Project/Property Address or Location: 6579 Taylor Rd.		Project Name/Business Name: Eastgate Commercial Park	
Parcel ID No.(s): 027-000008-00	Zoning Designation: OCT	Total Acreage: 7.6	
Description of Variance Requested: The current requirement is a 45 foot front parking setback. We are asking for a 22 foot front parking setback in order to meet the building space requirements due to the 80 foot right of way. Building code permits up to 0.5 foot candles in parking areas. We would ask for up to an average of 2.0 foot candles for safe and secure parking. Current requirements are for sidewalks to be added along the property frontage. Currently there are no sidewalks along Eastgate Blvd. We are asking to build the sidewalk once any other sidewalk is built.			
STAFF USE ONLY - Code Section(s): 1155.04(c)(1)(A) - Parking setback 1108.01(f) / 1107.01(d) - Sidewalks 1163.06(a) - Lightening			
APPLICANT Name-do not use a business name: Robert M. LeVeck		Applicant Address: 1500 W. Third Ave. Ste. 120 Co

PRELIMINARY SITE PLAN FOR:
EASTGATE COMMERCIAL PARK
THE CITY OF GAHANNA

Attn: Kelly Wicker, Administrative Assistant
RE: Project 6579 Taylor Rd Design Review Comment Letter Submittal 2
Proje

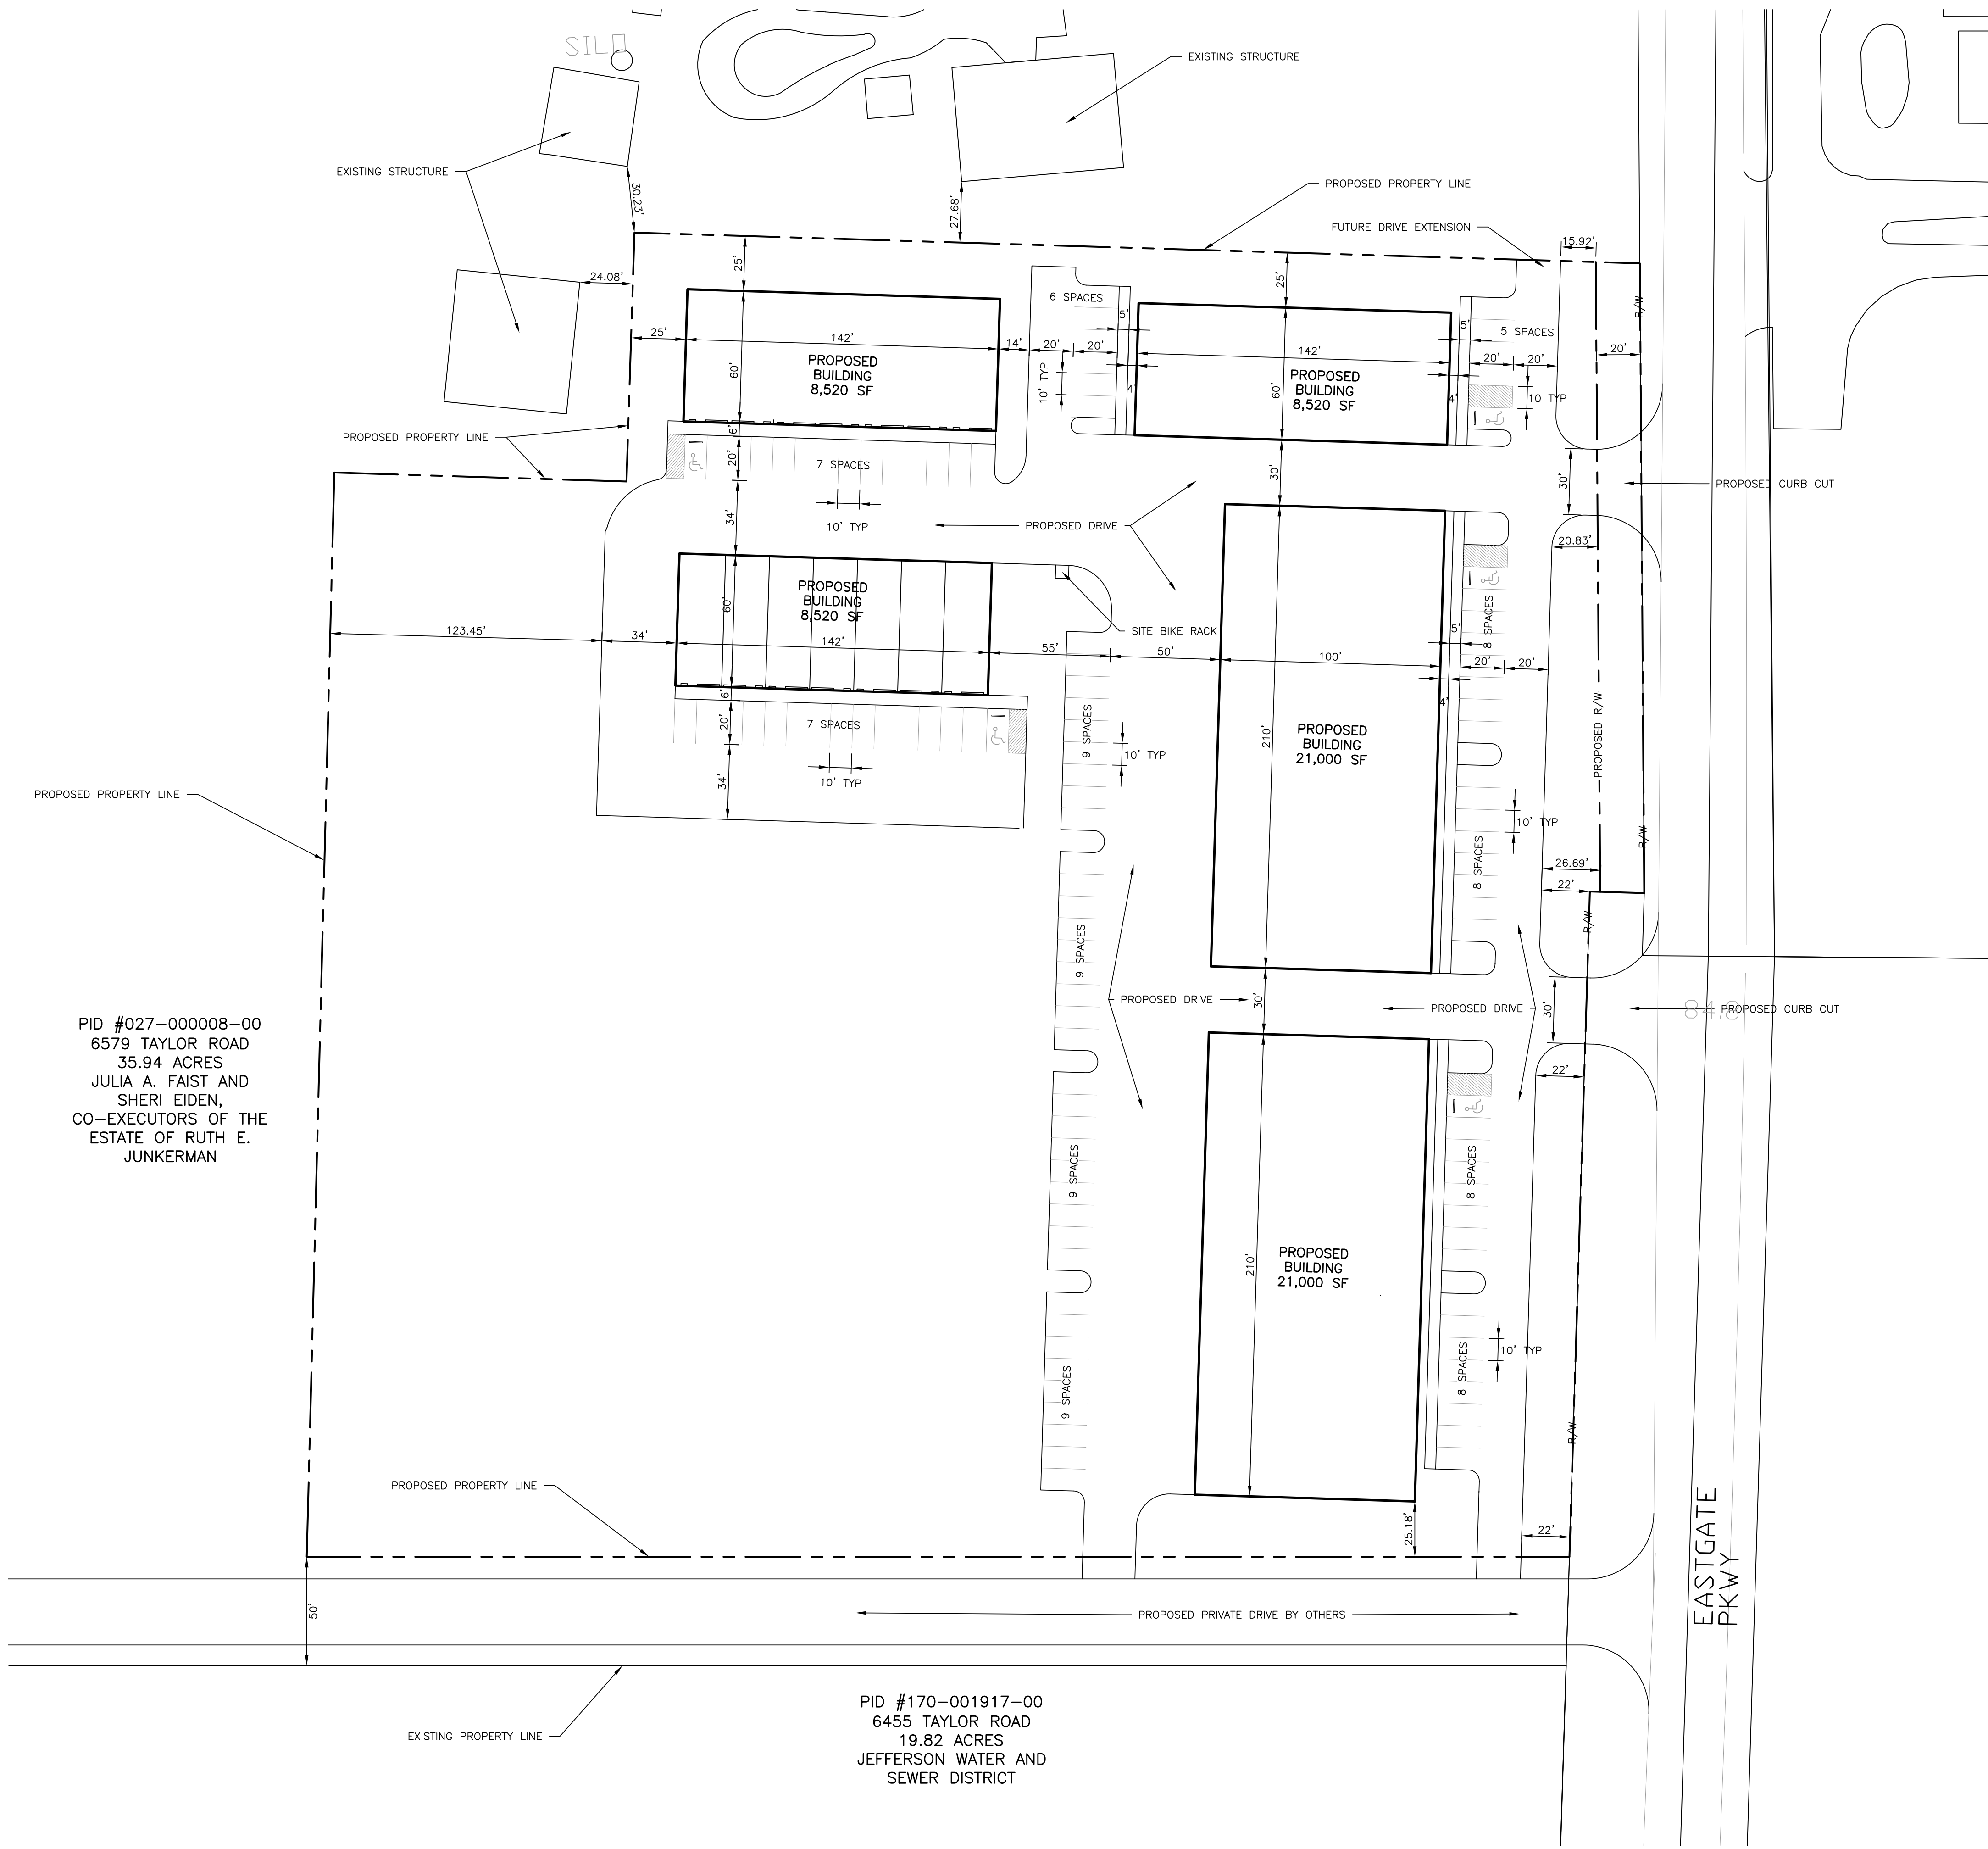
19. The parking calculations on the site plan don't quite match the zoning code's requirements. In addition to parking spaces based on building size, additional parking is required based on the number of business vehicles. Please estimate this number and revise the chart.

Additionally, the square footage of buildings listed in the table don't match the site plan.

Please review and revise accordingly. FYI - the site has substantially more parking than what the code requires, only the parking table will require modification.

8/20/19 - The requested changes haven't been made. Please see Chapter 1163.02 for additional details.

RESPONSE: The Landscape Plan has the correct parking layout and building areas. Civil engineering will be updated to reflect the Landscape Plan.
